SEPP Housing (Chapter 4) – APARTMENT DESIGN GUIDE ASSESSMENT
DA22/0408.02 – Residential flat building (95 units) at Lot 46 DP 1264557; No. 6 Grand Parade Casuarina

21st June 12pm (Winter Solstice)

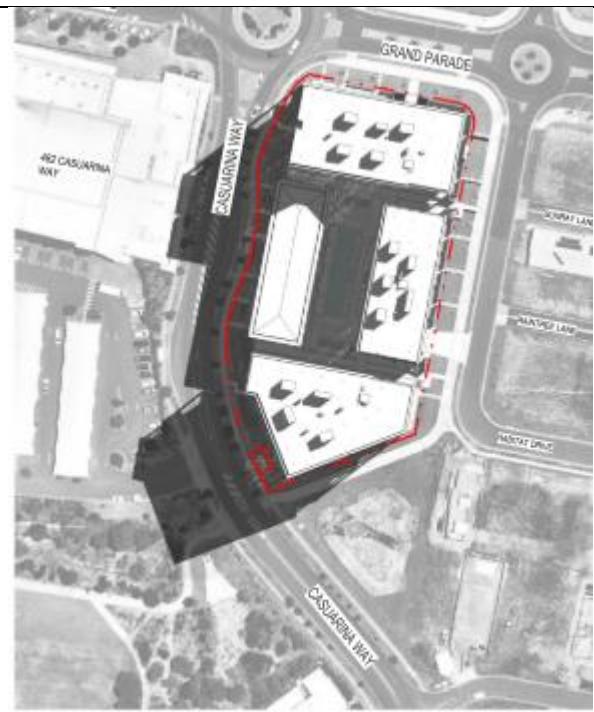
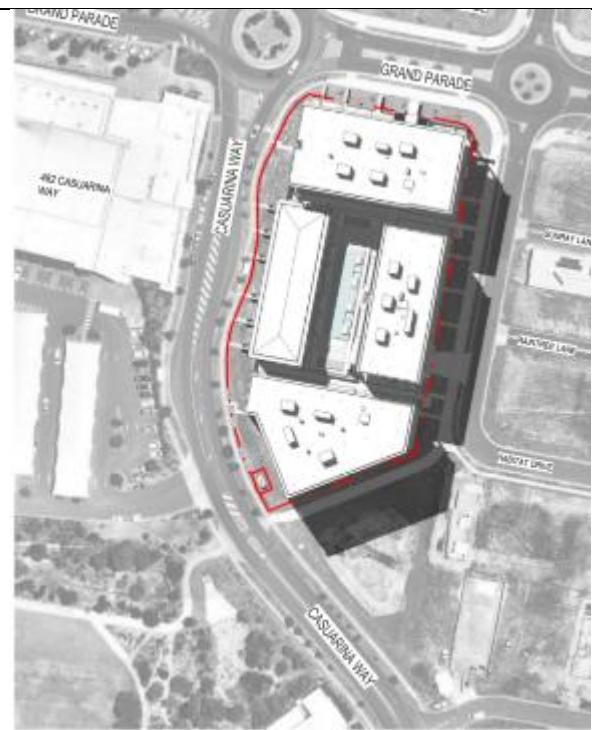
<p>Objective 3B-2</p> <p>Overshadowing of neighbouring properties is minimised during mid winter</p> <p>Design guidance</p> <p>Living areas, private open space and communal open space should receive solar access in accordance with sections 3D Communal and public open space and 4A Solar and daylight access</p> <p>Solar access to living rooms, balconies and private open spaces of neighbours should be considered</p> <p>Where an adjoining property does not currently receive the required hours of solar access, the proposed building ensures solar access to neighbouring properties is not reduced by more than 20%</p> <p>If the proposal will significantly reduce the solar access of neighbours, building separation should be increased beyond minimums contained in section 3F Visual privacy</p> <p>Overshadowing should be minimised to the south or down hill by increased upper level setbacks</p> <p>It is optimal to orientate buildings at 90 degrees to the boundary with neighbouring properties to minimise overshadowing and privacy impacts, particularly where minimum setbacks are used and where buildings are higher than the adjoining development</p> <p>A minimum of 4 hours of solar access should be retained to solar collectors on neighbouring buildings</p>	<p>Acceptable</p> <p>Refer to Section 3D and 4A.</p> <p>Shadowing will occur over the western neighbouring sites which contains a shopping centre and outdoor carpark, Council owned operational land and Council owned community land at 9am on 21 June. By 12pm, no shadowing will fall on these properties. The shadowing which is falling on the community land is minimal and contained to vegetation and therefore will not negatively impact the useability and amenity of this park. Shadowing will occur over the southern neighbouring site which is Council owned operational land over a portion of its surface throughout the day on 21 June. At 3pm on 21 June it appears there is a small area of shadowing which will fall on 14 Habitat Drive which contains a residential dwelling. This does not impact on their main POS area which is located in the rear yard, nor on the solar panels. Therefore, the overshadowing from the proposed development is considered acceptable.</p>

Proposed:

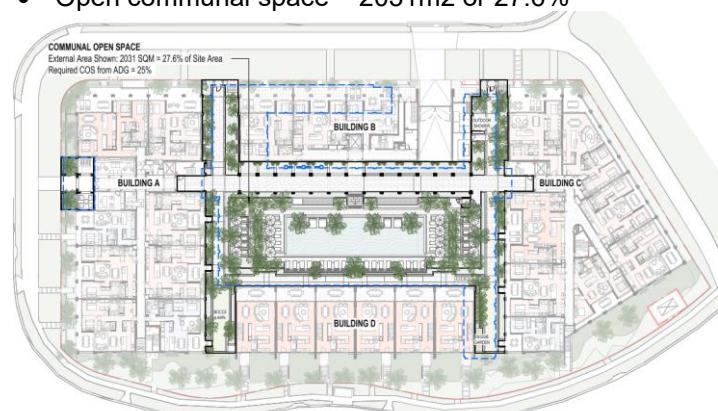
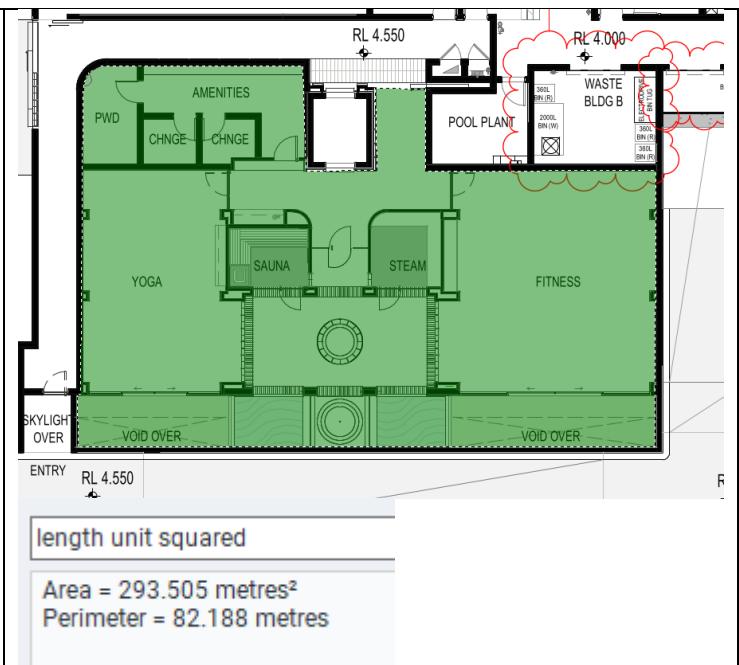
- Open communal space – 2031m² or 27.6%
- Indoor communal facilities – 293.5m²

The proposed modification is resulting in an increase to outdoor COS which is considered appropriate given the increase in unit numbers.

The principal area of COS being the swimming pool will receive 2hrs of direct sunlight between 12pm and 2pm on 21 June.
